# 1992 Corvette: Service Bulletin: Brake Pedal Not Fully Returning / Stop Lights Stay On and/or Roughness/Vibration From Rear of Vehicle

**Subject:** BRAKE PEDAL NOT FULLY RETURNING, STOP LIGHTS STAY ON, AND/OR ROUGHNESS-VIBRATION-NOISE FROM REAR OF VEHICLE

**Model and Year:** 1992 CHEVROLET CORVETTE

**Bulletin Number:** 92-71A-5 - (01/31/1992)

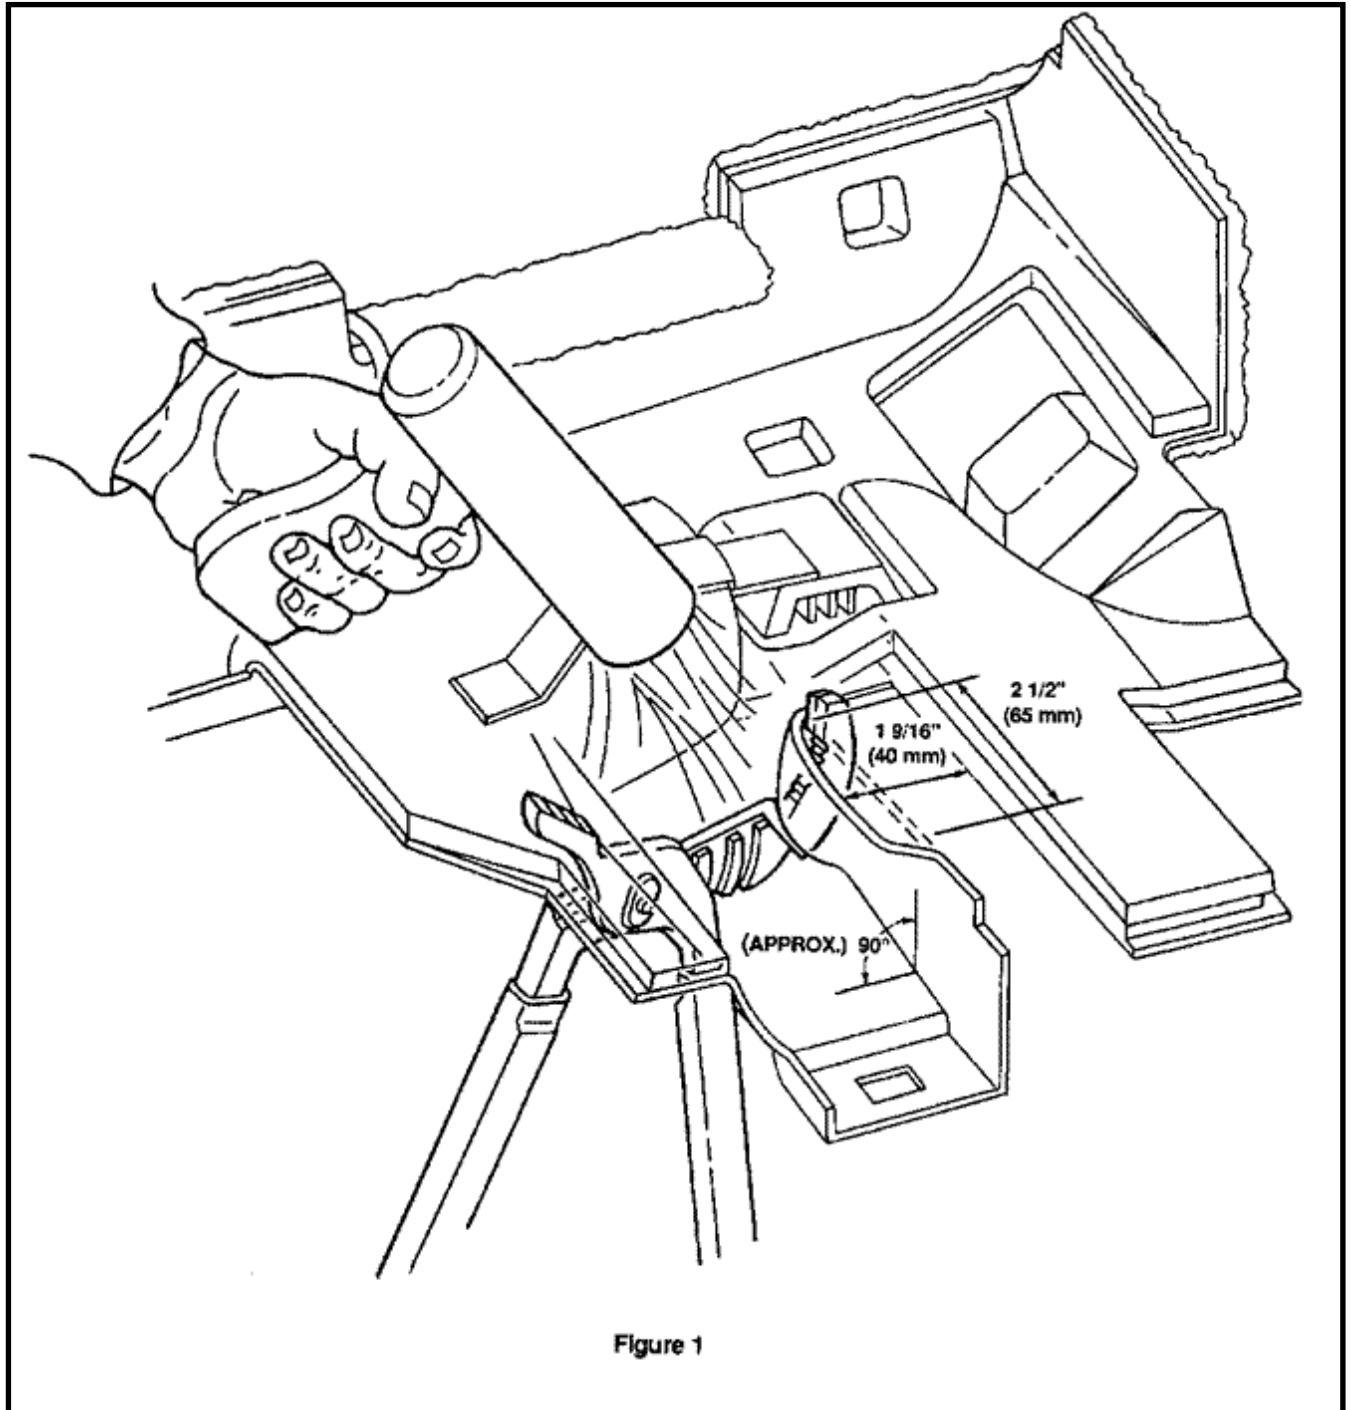
Some 1992 Y-car base Corvettes built from SOP to VIN breakpoint 104324 and ZR1's built from SOP to VIN breakpoint 800193 may exhibit inadequate clearance between the brake service pedal arm and the I/P lower trim panel.

Determine if interference exists between brake pedal arm and I/P lower trim panel (a minimum clearance of 2mm (.080 in.) is required). To verify clearance, an item approximately 2mm thick, such as a 2mm shim, should pass between the trim panel and pedal arm on both sides. If there is clearance, diagnose concern per Service Manual, Section 5-3. If the minimum clearance does not exist, perform the following steps:

1. Remove LH lower trim panel (per Service Manual, Section 8C-33).
2. Lift away the foam sound deadener from area shown in Figure #1, and tape out of the way.
3. Using a heat gun, warm the trim panel area shown in Figure #1 (USE CARE TO WARM COMPLETE AREA EVENLY).
4. Using Channel Locks (R) size 16 or larger, place near the upper LH corner of the I/P lower trim panel as shown in Figure 1. Quickly reform the brake pedal opening to configuration and dimensions indicated in illustration. If necessary Channel Locks may be moved downward during initial reforming and/or Steps 3 and 4 may be repeated to obtain minimum clearance of 2mm between the brake service pedal arm and the I/P trim panel.

**Note: To lessen Channel Lock imprint, place smooth shim stock or aluminum face cover between the Channel Lock face and the warmed surface on the trim panel.**

5. Reinstall lower trim panel. Remeasure the clearance between trim panel and the brake pedal arm, using method stated in correction above.
6. If contact still exists, phone Action Center #1 -800-457-8388.
